Cap, 24/410, flip
top, screw on, PP

108933

EXTERNAL PRODUCT DRAWING A4

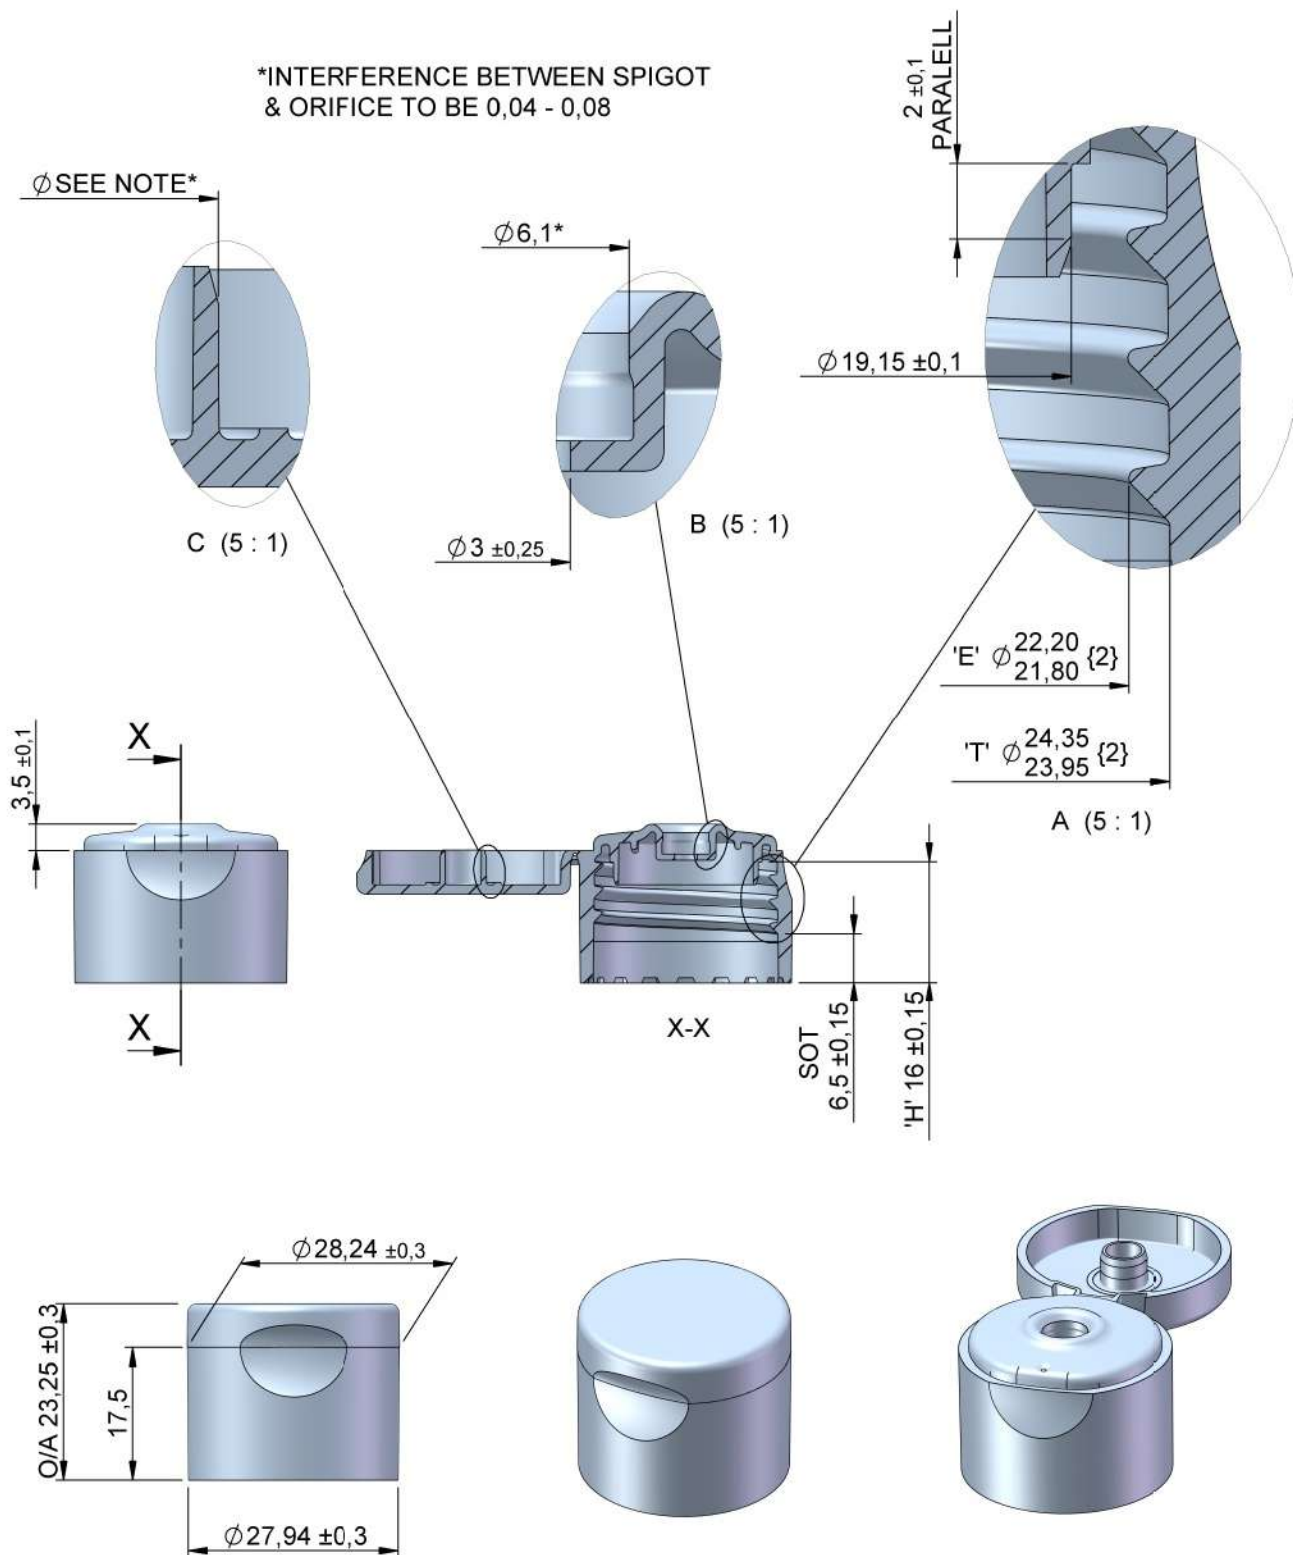
ISSUE	DATE	REQUEST NO.
1	05/03/12	DOR JM
2	09/05/18M	DCR 608 - 'E' 21,8 / 22,2 WAS 21,84 / 22,09 'T' 23,95 / 24,35 WAS 23,97 / 24,22
3	06/12/18W	DCR 1003 - WEIGHT TOLERANCE 0,48g WAS 10%
4	12/09/24M	DCR OI-04894 - RECOMMENDED TORQUE REMOVED
